Stop Use & Product Recall
IMMEDIATE ACTION REQUIRED
3M™ PROTECTA® Cobra Rope Grab AC202D

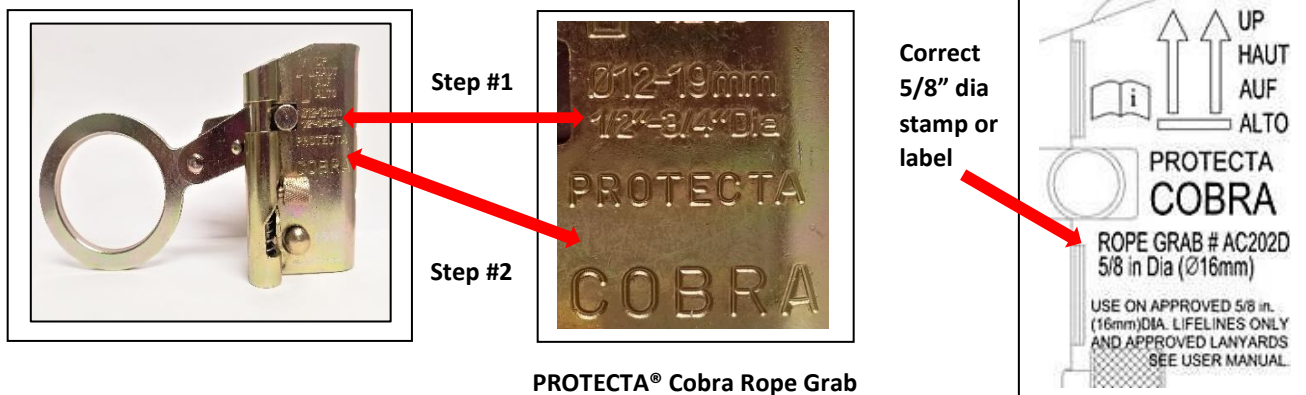
3M Fall Protection has determined that the 3M™ PROTECTA® Cobra Mobile/Manual Rope Grab AC202D is incorrectly stamped for use with 1/2 to 3/4 inch diameter rope on the exterior body of the unit. This Cobra Rope Grab is certified for use **ONLY** with 5/8 inch diameter polyester or polypropylene rope. All marketing information and the Instructions for Use (IFU) for this rope grab correctly identify the size of rope to be used as 5/8 inch polyester/polypropylene rope.

Step 1: Verify the rope diameter is stamped **1/2"—3/4" Dia** on the front side of the unit

Step 2: Verify the rope grab is stamped **PROTECTA COBRA** on the front side of the unit

Note: If the unit is stamped 5/8 inch diameter **OR** if the unit has a white label showing 5/8 inch diameter, then the unit is safe to return to normal use (see image on right for correct 5/8" diameter marking).

If the information in Step 1 and Step 2 is stamped onto the side of the rope grab as illustrated above, remove the unit from service immediately. Owners of AC202D Cobra Rope Grabs can choose one of the following options for each affected rope grab they own:

1. A free, new, properly marked replacement AC202D Cobra Rope Grab; or
2. A check for \$100.
